TYPEC CONNECTOR

File		<Title>
Rev		Document Number
D		<Doc>
Date		September 24, 2019
Page		2 of 3

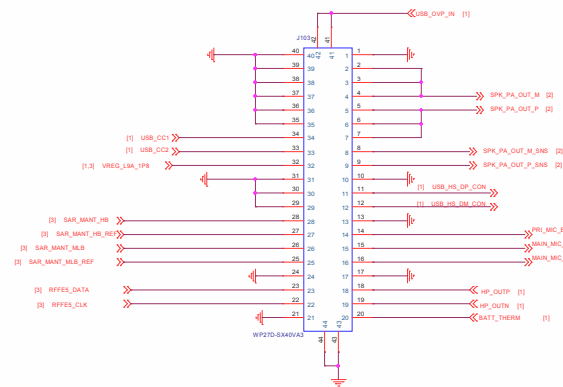
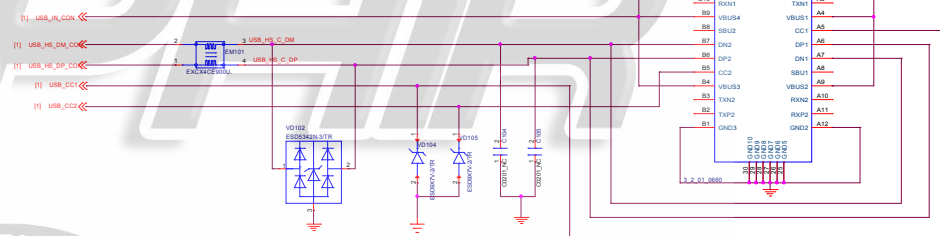
VD101 NA sku should be 18V; other SKUs should be 15V
